# NON-COMPLIANCE RECALL J050 [NHTSA# 15V-037]: OCS HANDBOOK DESCRIPTION INCORRECT - UPDATE

SERVICE  
BULLETIN

NO.: 7-096USA

**THIS BULLETIN UPDATES 7-095USA**

E164858

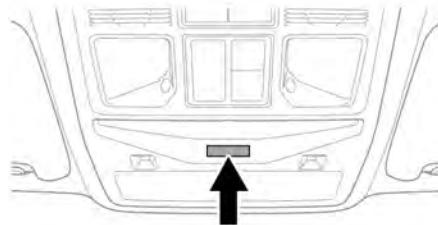
The system will adjust the passenger air bag status and operate the status indicator as follows:

Occupancy status	Passenger air bag status	Status indicator display
Completely empty	Deactivated	No indication given*
Child restraint or low weight occupant/object	Deactivated	PASSENGER AIRBAG OFF**
Heavy occupant/object	Activated	No indication given

\* It is possible to receive an intermittent indicator illumination with an empty seat. This is part of the system's adaptive behavior and does not affect the status of the front passenger air bags. However, if the indicator becomes permanently illuminated when the seat is empty and the seat belt is unbuckled, contact your Dealer/Authorized Repairer immediately.

\*\* In some cases, a small child placed in a child seat may not activate the deactivation indicator. If this occurs, the front passenger air bag status will be as described for an empty seat.
